1320 East Pine

REVOLVE
DRB RECOMMENDATION MEETING / **SDCI** #3033207-LU / 27 JAN 2021

RECOMMENDATION RESPONSE SUMMARY

DETAIL VIEW AT VENT

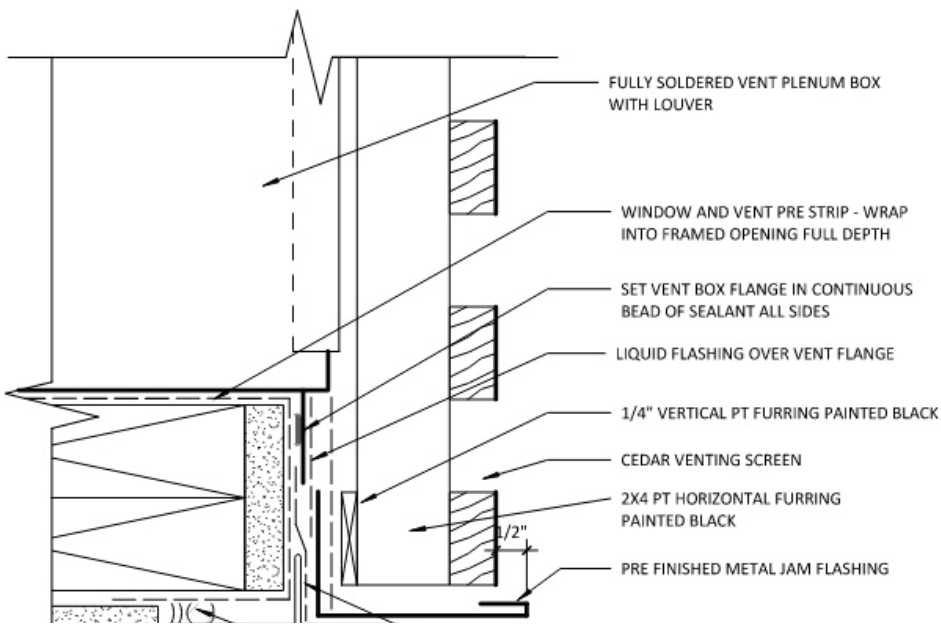
- D. Include a fine grain of architectural and material detailing to create a cohesive design. Integrate venting and consider using balconies to soften the facade. (CS2-A, DC2-B, DC4-A)

The venting is integrated behind the siding in a seamless expression of the fenestration pattern; small reveals in the boards provides the ventilation. The wood vent screening is oriented vertically or horizontally to match the orientation of the adjacent siding.

VIEW OF EGRESS AT WEST EDGE OF PINE ST. FACADE

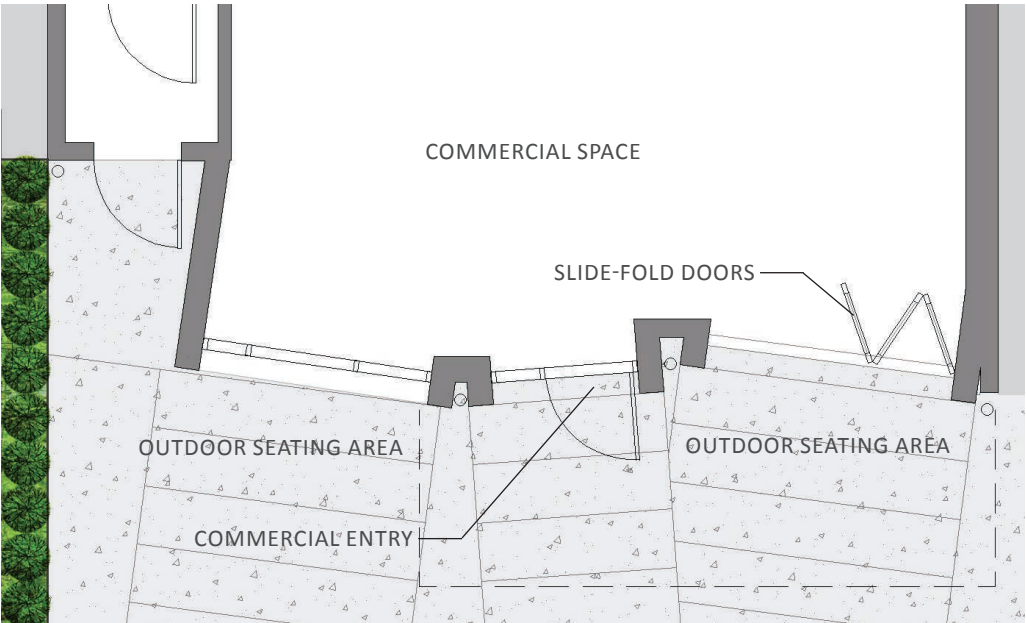
D. Treat any ground-level blank walls to reinforce the design concept. Consider incorporating glazing and/or lighting. (CS2-A, CS3-A, DC2, PL3-IV)

We have pulled back a portion of the façade approximately 5'-0" from the west property line to allow for secondary articulation of the massing and highlight the contrast between the static planes off the party wall with the dynamic/angled planes off the retail frontage. This also creates a defined space at the corner and allow the westernmost 'box' to be further rendered as a discrete object. Furthermore, this pushes the required egress door at the west edge further from the sidewalk in an effort minimize its impact on the street composition.

LOOKING WEST FROM SIDEWALK AT NORTH FACING “COTTAGES”

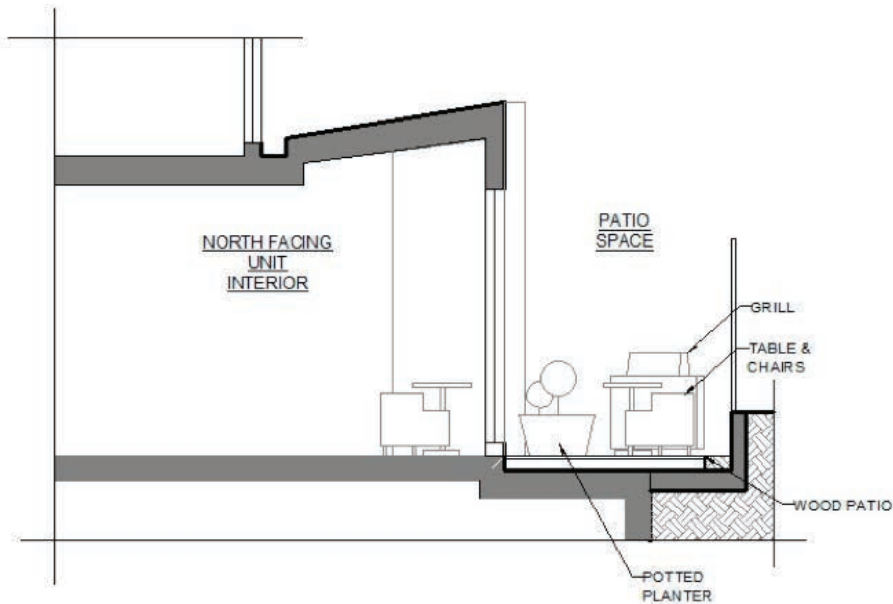
B. Clarify how pedestrian access will be accommodated or discouraged from the street. The Board discouraged the use of a gate. (PL3-B, PL3-II)

To provide a signal that the patios are private, we eliminated the service path that ran from the patios to the sidewalk. We designed a landscaped buffer with substantial plantings that clearly define the private patios from the public sidewalk while providing clear visual access for security and safety. In addition to the adjacent perspective, see the rendered Landscape plans to see the context and design.

DETAIL SECTION OF “COTTAGE” AND ADJACENT PATIO

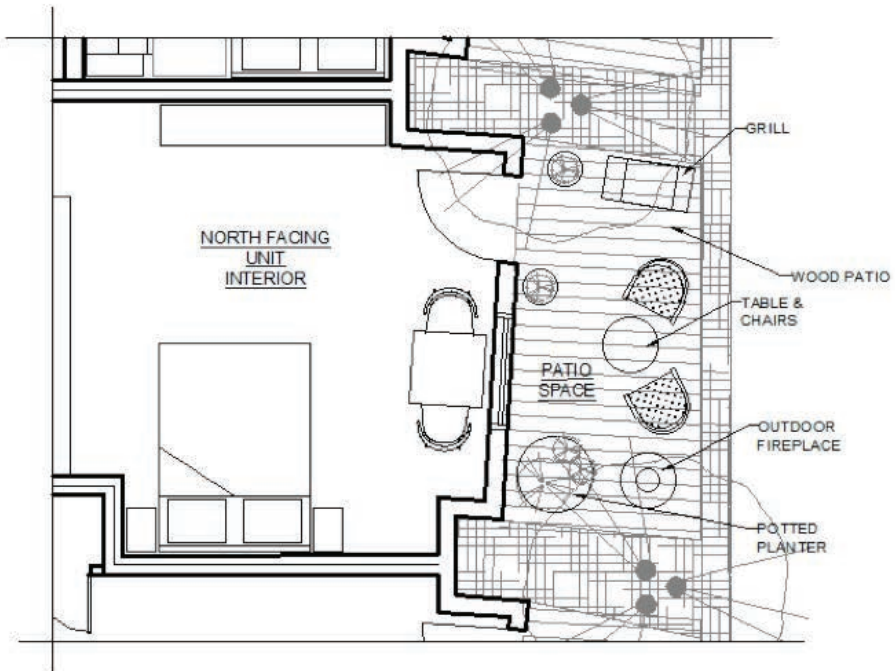
A. In plan view, demonstrate how the interior programming will activate the setback space. In plan and section, demonstrate the setback space is a sufficient width to facilitate urban outdoor living. (PL3-B, PL3-II)

Each unit has their most public space, the Living Room, adjacent to the outdoor patio area. The glass swing door and adjacent operable window allow for the interior space to spill out onto the patio. Furthermore the north-south orientation of the exterior decking surface will match that of the orientation of the interior flooring, providing another connective element. See the attached plan and section study that shows how the space could be activated and how it would spatially related to the Living area of the unit. (Plan and section study of North patio activation)

RESIDENTIAL LOBBY, ENLARGED PLAN

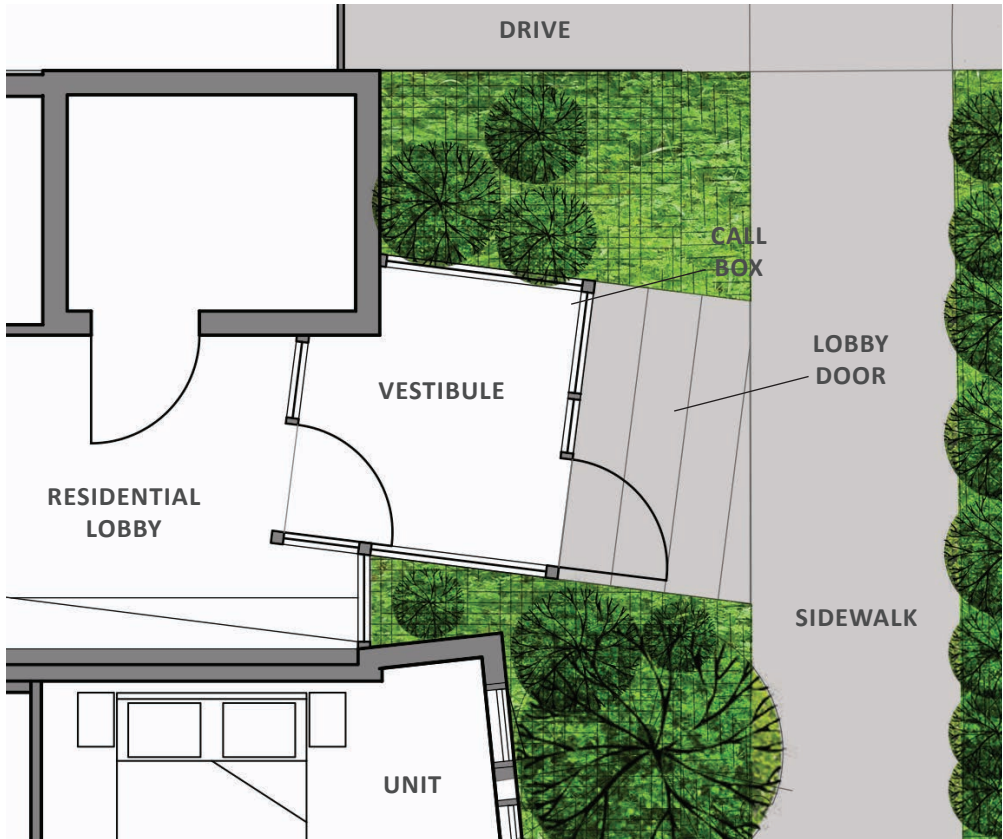
A. At the Recommendation Meeting demonstrate how the garage access provides clear sight lines to passing pedestrians while also minimizing the visual impacts. (DC1-B, DC1-C, DC1-II)

The garage door is setback from the street more the 10’ to provide for clear sight lines on either side of the drive ramp to the sidewalk. The garage door has been incorporated into the design of the facade as to be cleanly presented while not drawing too much attention to it.

PLAN DETAIL AT P1/LEVEL 1 SHOWING BIKE ROOM ACCESS, TRASH ROOM AND COLLECTION DAY STAGING AREA ON 14TH AVE.

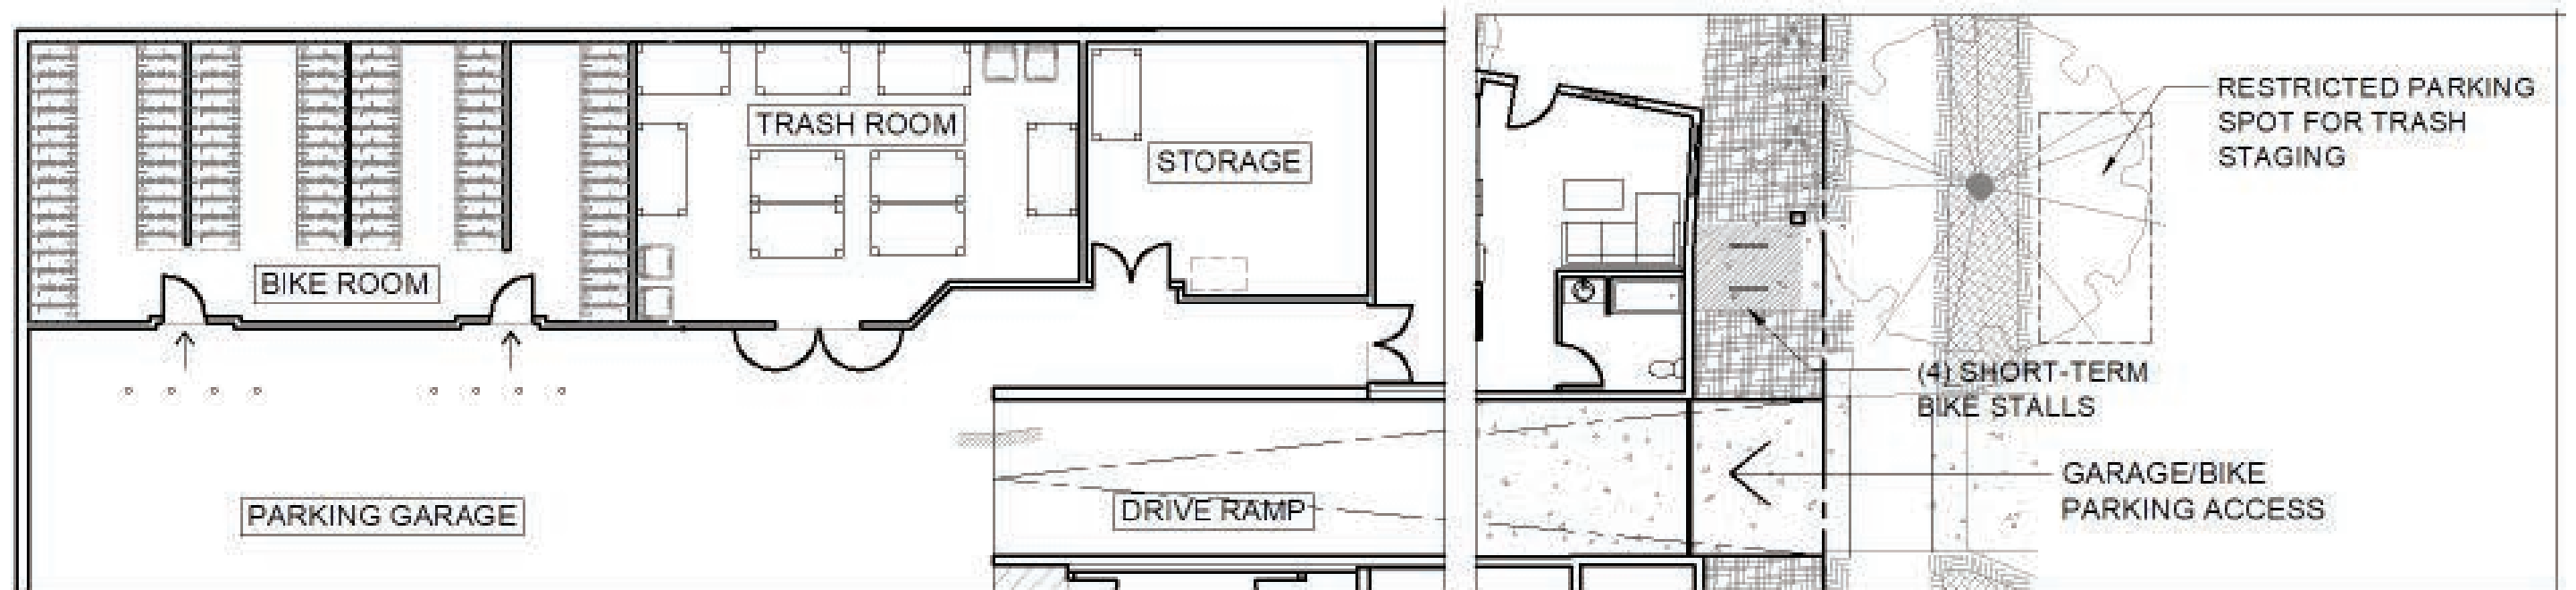
C. At the Recommendation Meeting provide details for the garage door and other back of house access doors. (DC1-B, DC1-C, DC1-II)

See plan below for garage door location in relation to other back of house access doors which are all located in the below grade garage.

We have provided a bike room at the bottom of the drive ramp and provide two entry doors at either end of the bike room for easy access and storage. We have also provided a protected staging area outside the bike room in the parking garage to further promote ease of use.

SECTION AT NORTH PROPERTY LINE

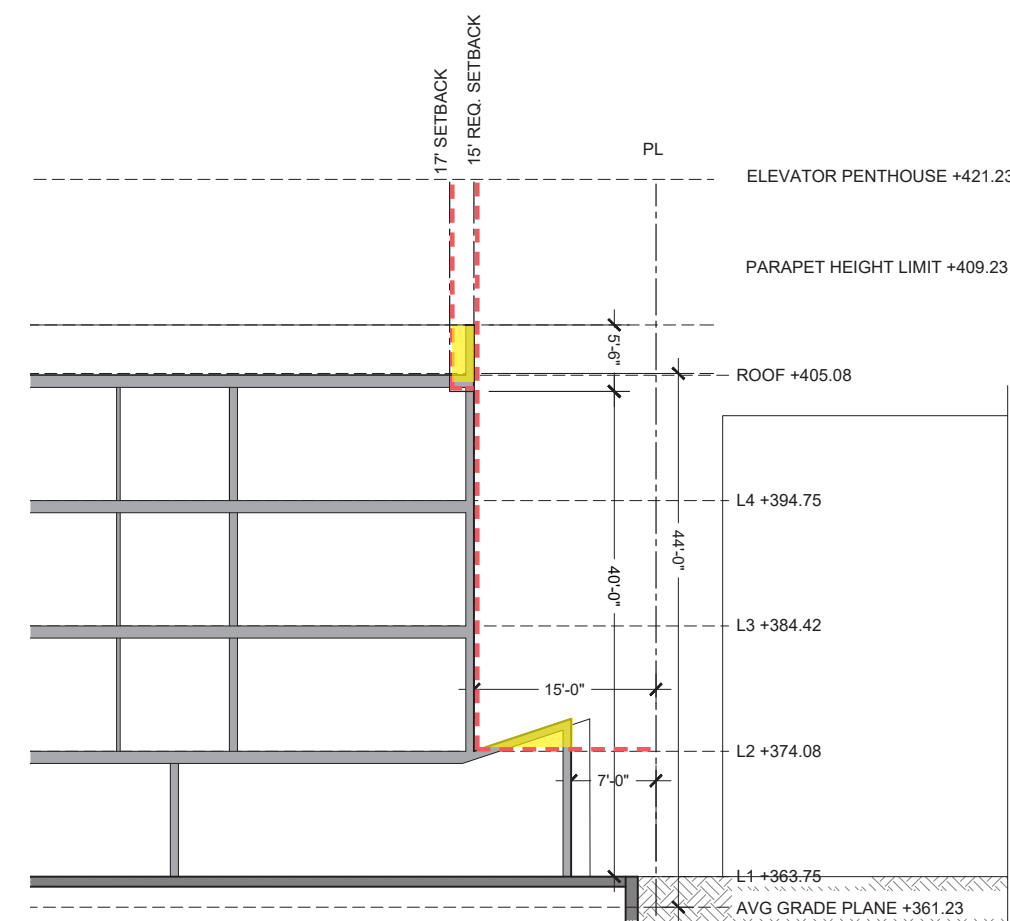
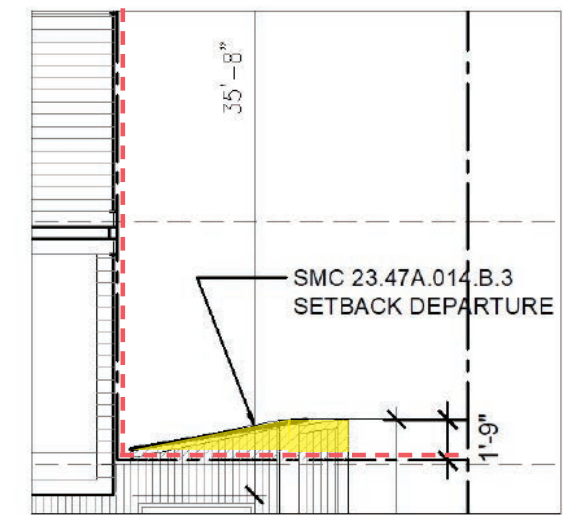
PROPOSED:
At the north façade, allow encroachment of 2 feet into the 17 foot setback from building height 40 feet to 48 feet. 4 ft of the 8ft of the vertical encroachment is parapet. See A-300 “Building Sections” for the area of encroachment.

RATIONALE:
The departure allows us to maintain a consistent façade plane along the north lot line rather than stepping the 4th floor back 2 feet. This provides the building with a cleaner massing; consistent with many other building facades in our neighborhood. In addition, we are offsetting the small addition of bulk at the top of the building by puling the base well inside the allowable zoning envelope which is 13 feet tall and goes all the way to the north property line. The Board indicated during the EDG meeting that they would likely support this Departure request.

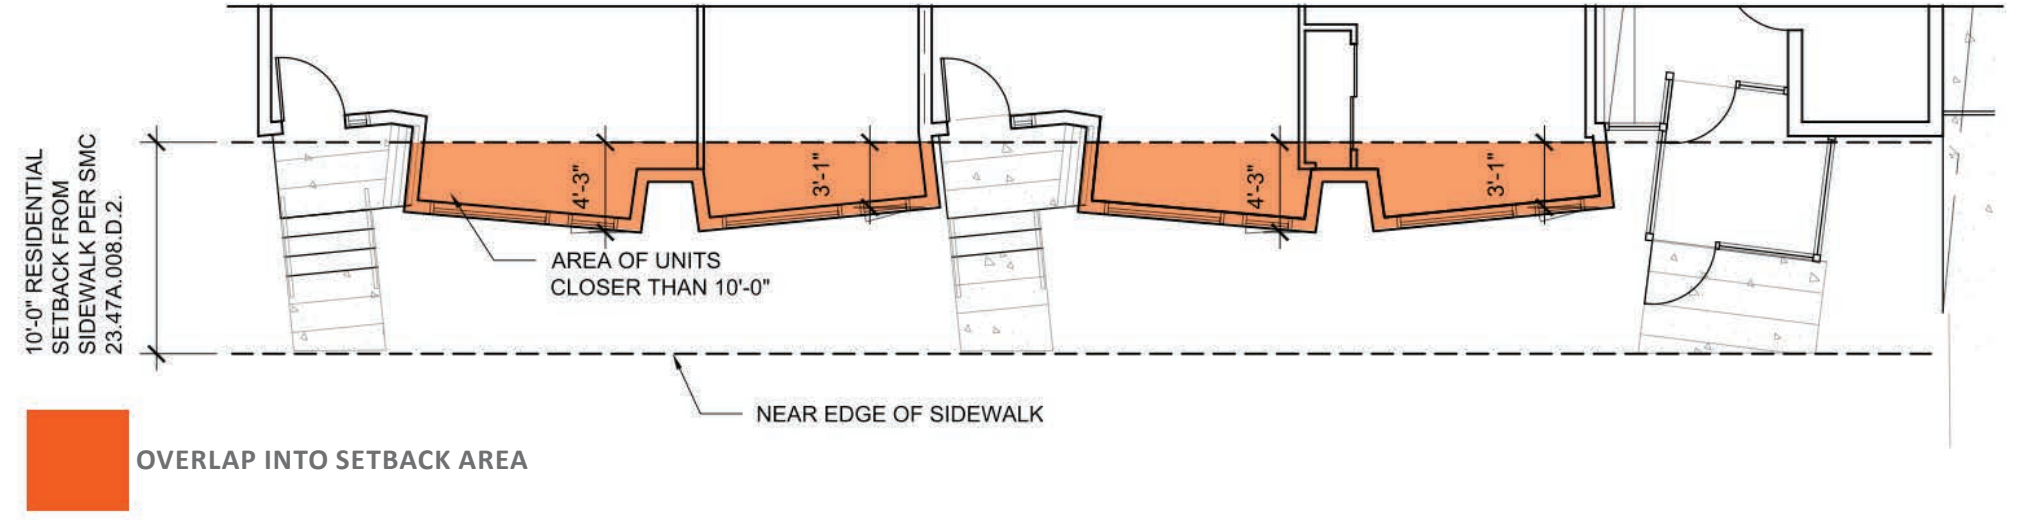
Allow the ground floor residential units along 14th Avenue to be located within the 10 foot setback requirement from the sidewalk.

At the early design guidance meeting, the Board expressed some concern that the building overhang along 14th was too deep. They asked us to determine the optimal proportion (height and depth) to allow light into the stoops and the units, and voiced willingness to support a ground level setback departure request if it's necessary to respond to the early design guidance for the stoop design.

As noted by the Board and after careful internal study, we determined that having the entire ground floor expression pushed by 10' from sidewalk (zoning code requirement) didn't provide the optimal proportion to allow in light. To create a balance between access to light and privacy, we pulled the majority of the residential unit out so it sat 6' back from sidewalk, while still providing a recessed entry recessed entry that provides an stair with elevated entry landing. As to not be too compact, we incorporated a small "bench" adjacent to the entry door that is enough to set down groceries or other items while letting oneself into the apartment. Pulling the portion of the unit façade closer to the sidewalk minimizes the overhang and helps provide better access to natural light into the unit. The shapes and placement of the windows, work to create a balance between activation, access to light and air and providing an appropriate level of privacy. The careful balance of all these components produces a unit that helps activate the street (i.e. less reliance on blinds) but still affords privacy for the tenant.

DETAIL PERSPECTIVE OF RETAIL FACADE

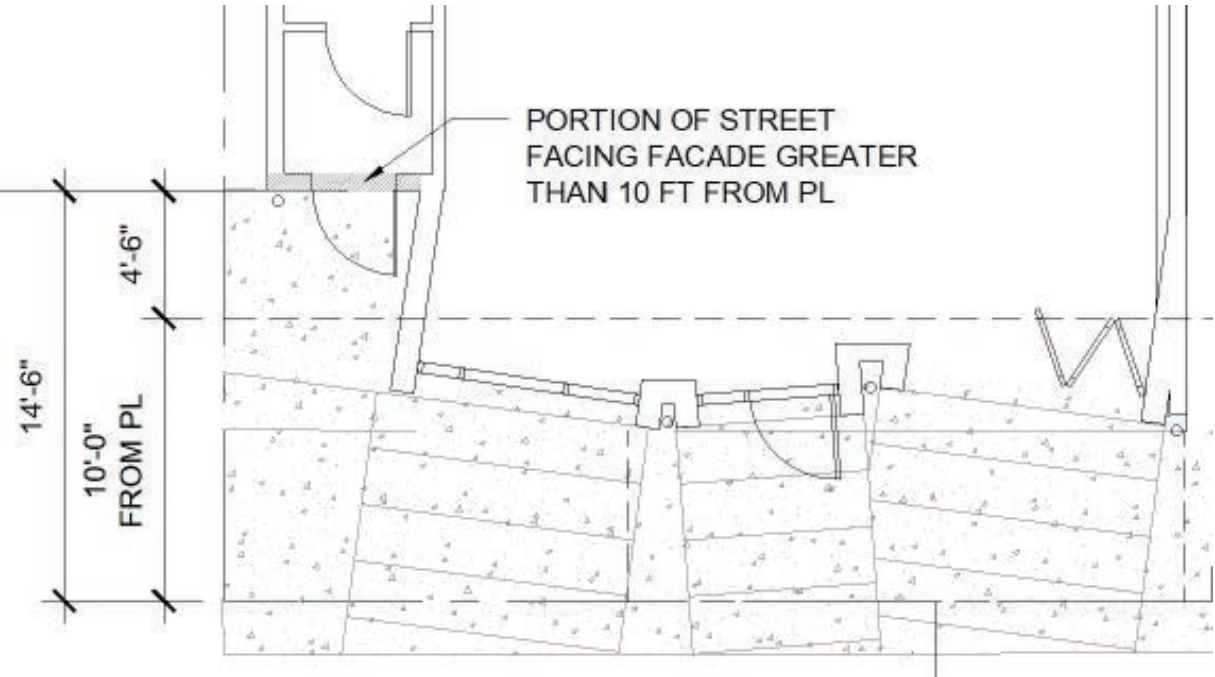
In an effort to better meet the recommendation of the Board at the EDG meeting, we reworked the design of the west facade to provide more activation at the southwest corner. To that end, we have pulled back a portion of the west façade an additional 4'-6" from the 10'-0" maximum setback to create this secondary articulation of the massing and highlight the contrast between the static planes off the party wall and return with the dynamic/angled planes off the retail frontage. In addition to increased visual interest the Board was looking for, this also creates a defined space at the corner and allow the westernmost retail 'box' to be further rendered as a discrete object. Furthermore, this pushes the required egress door at the west edge further from the sidewalk in an effort minimize its impact on the street composition.

We believe diminishing the impact of the non-active egress door and highlighting the active retail facade better meets the intent of the Design Guidelines.
